File Number: 8-M-26-IH

Meeting: 8/19/2026
Applicant: Amber Culpepper Lafayette Properties
Owner: Amber Culpepper Lafayette Properties
District: Lonsdale Infill Housing Overlay District

Location: 915 Minnesota Ave. **Parcel ID:** 81 H F 013
Zoning: RN-2 (Single-Family Residential Neighborhood)
Description: New primary structure

Staff Recommendation

CONCEPT SITE PLAN

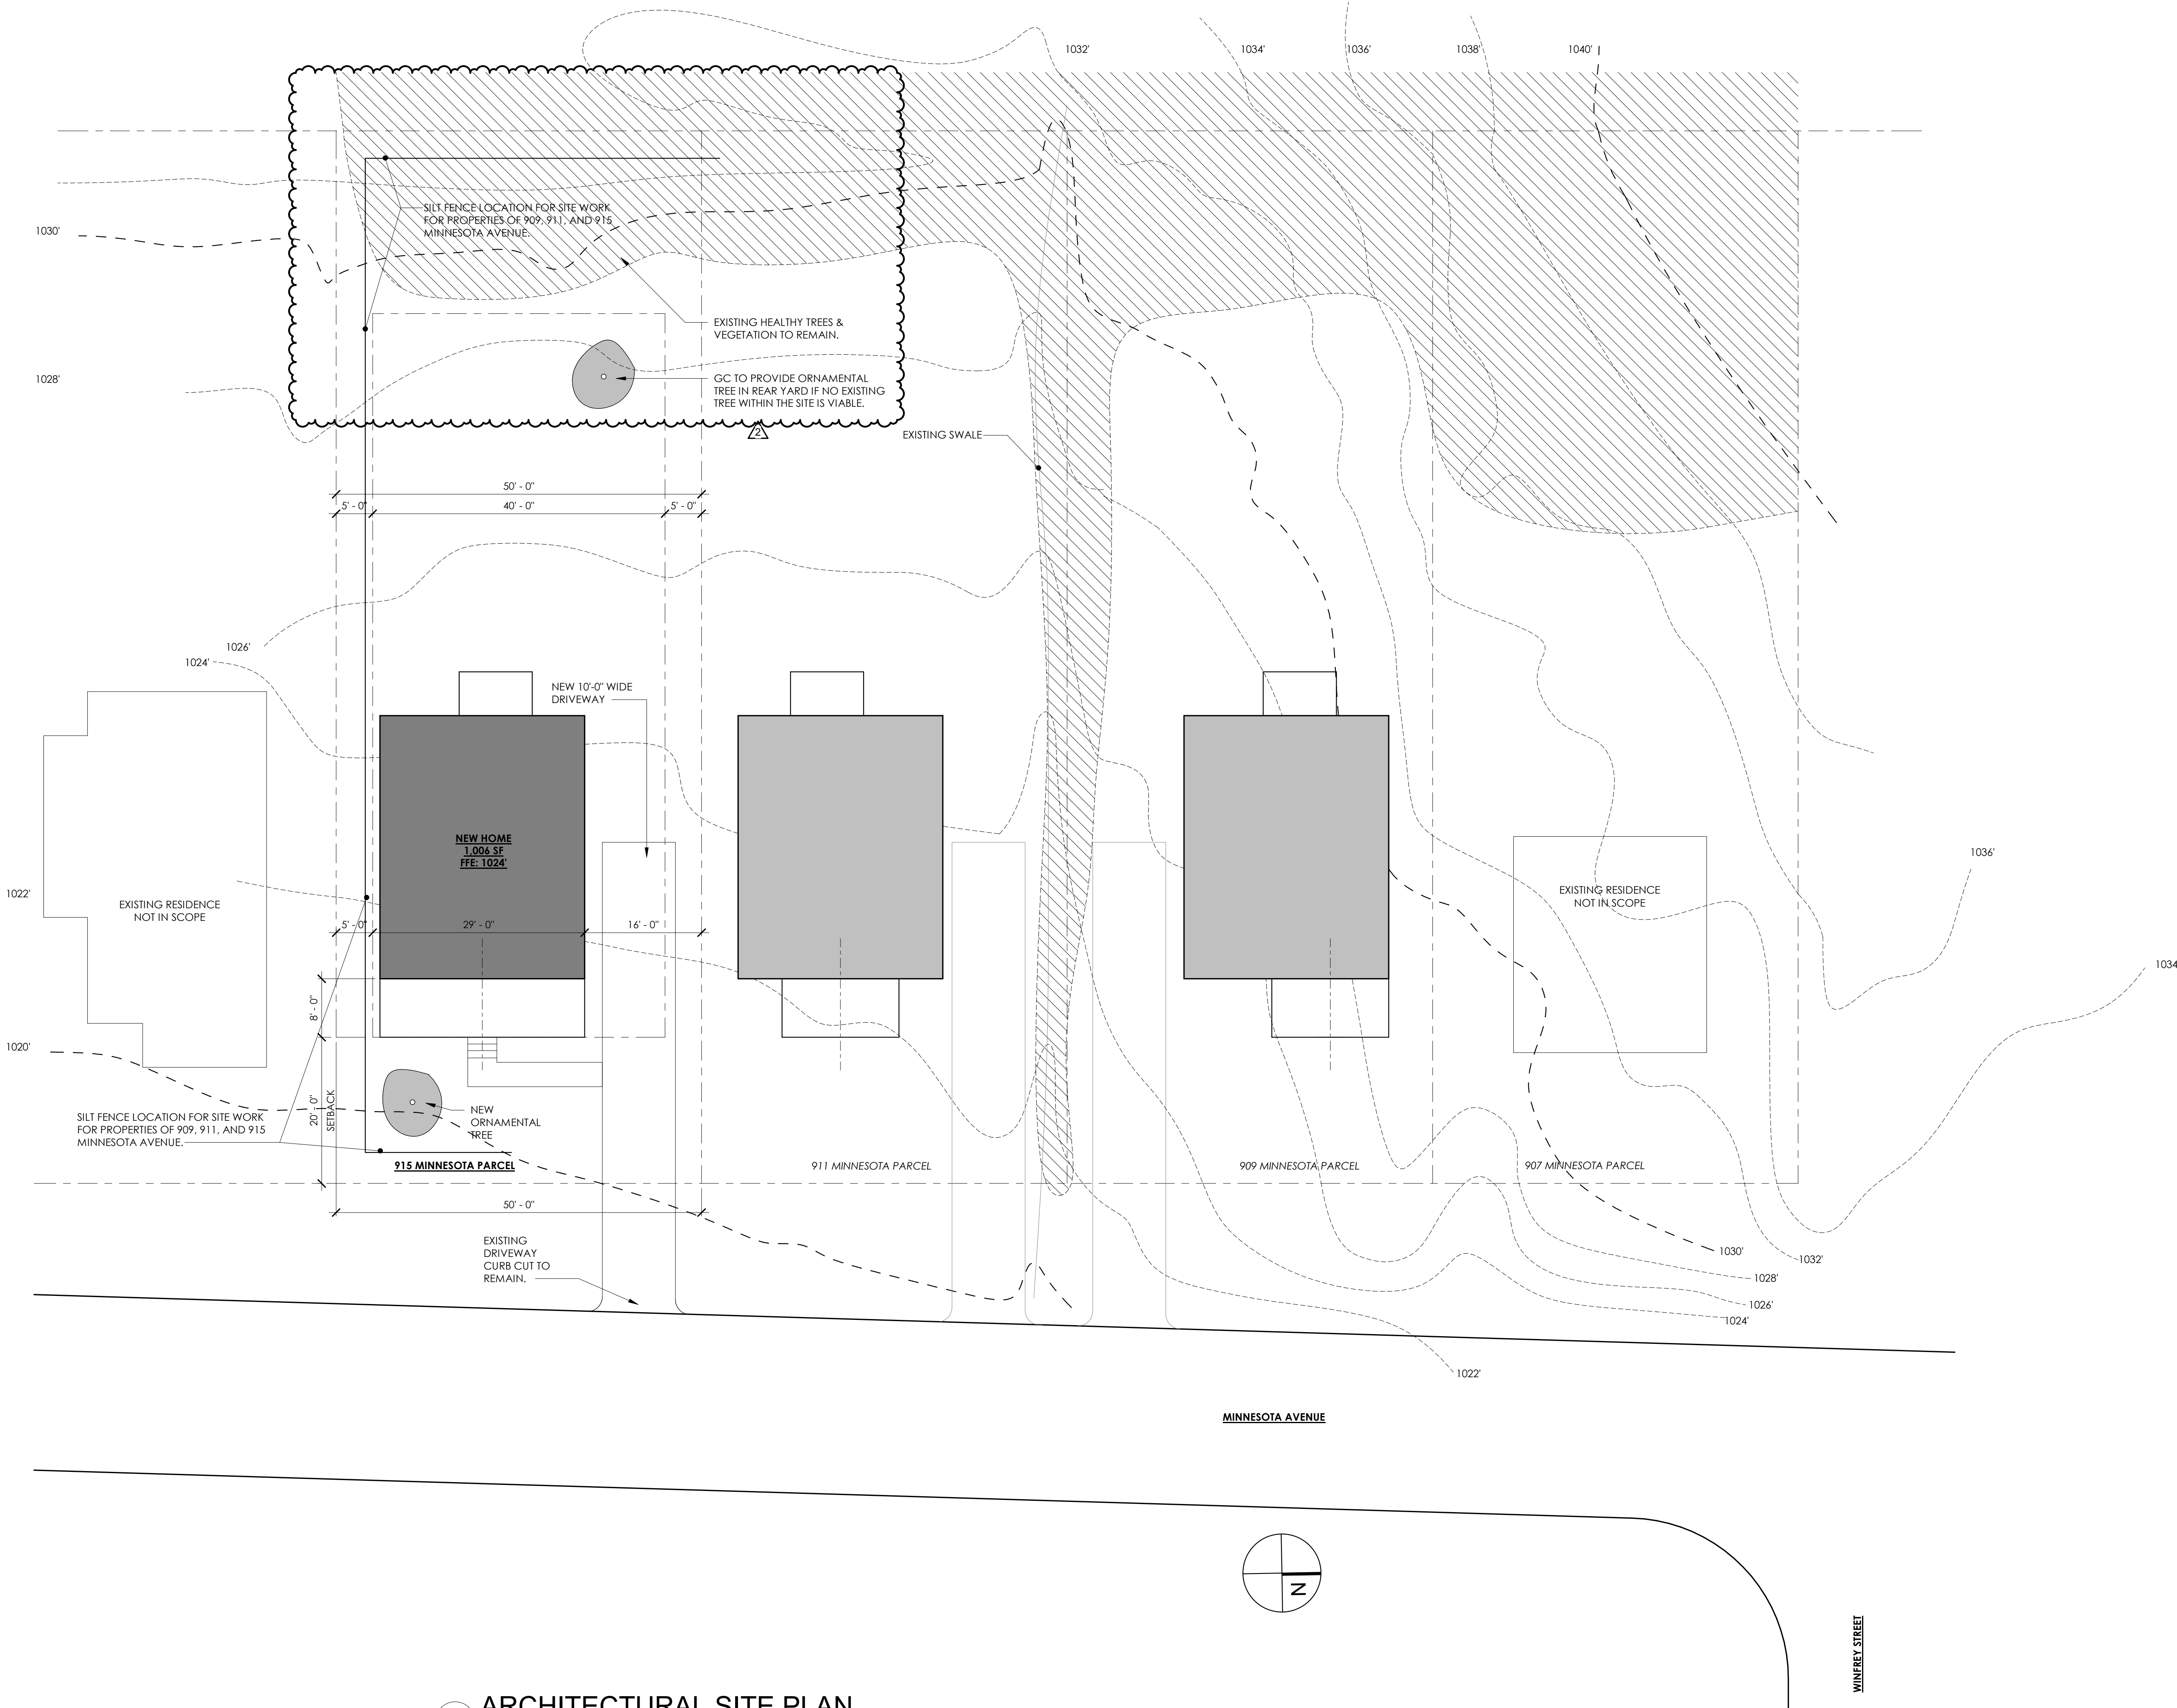
Front Yards: Setback is consistent with the blockface's average front setback (approximately 20'). The walkway in the

front yard should be revised to connect to the existing sidewalk within the property or along the road.

Alleys, Parking, and Services: The existing alley right-of-way along the rear side of the property is unbuilt. Access from the street using the existing curb cut is appropriate. Revisions to the site plan may be necessary to meet City Engineering standards.

Landscape: Appropriate. Applicant indicates the existing vegetation along the rear side of the property will be retained. Documentation should be provided to staff if it is not feasible to retain existing, healthy trees in the rear yard, and a new shade tree should be planted.

- 1) preserving the existing public tree next to the proposed driveway and the tree in the rear yard to be an existing healthy tree, as possible, with documentation submitted to staff;
 - 2) revising the walkway in the front yard to connect to the sidewalk;
 - 3 the final site plan to meet City Engineering standards, with minor revisions to be approved by staff;
 - 4) major changes to the foundation height to return to the Board for review;
 - 5) final guardrail materials to meet Infill Housing design guidelines.
-

1 FRONT ELEVATION
1/4" = 1'-0"

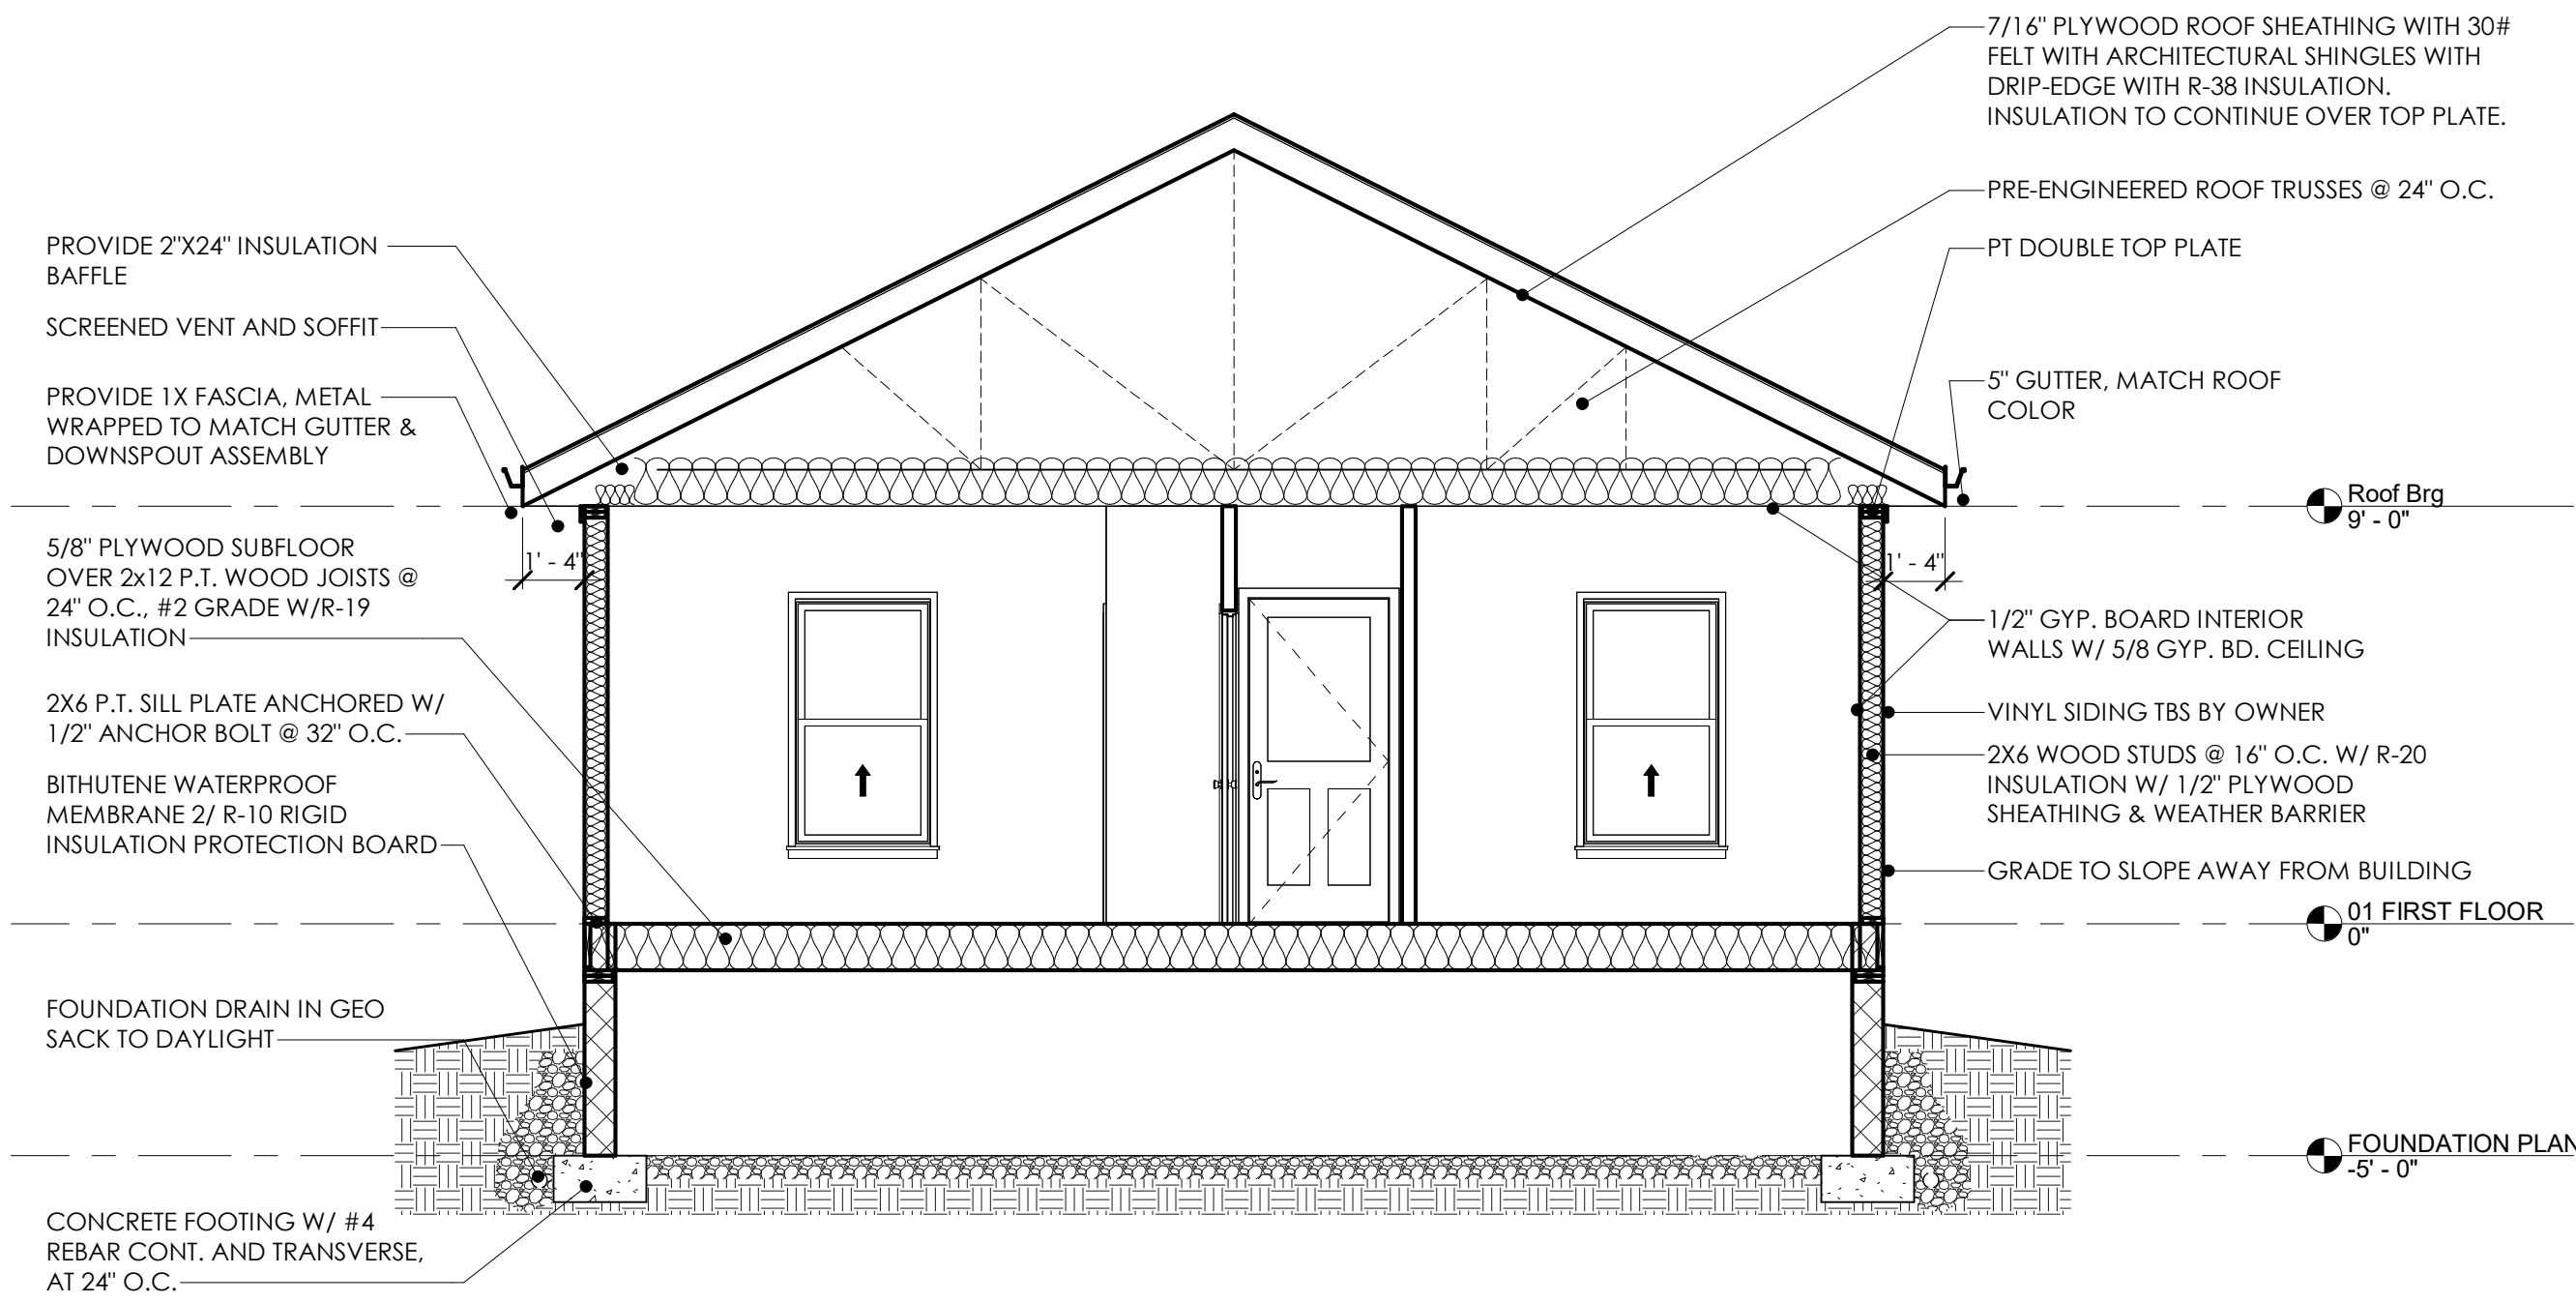
Porches and Stoops: Appropriate. The applicant should specify guardrail materials, which should not be metal per the design guidelines.
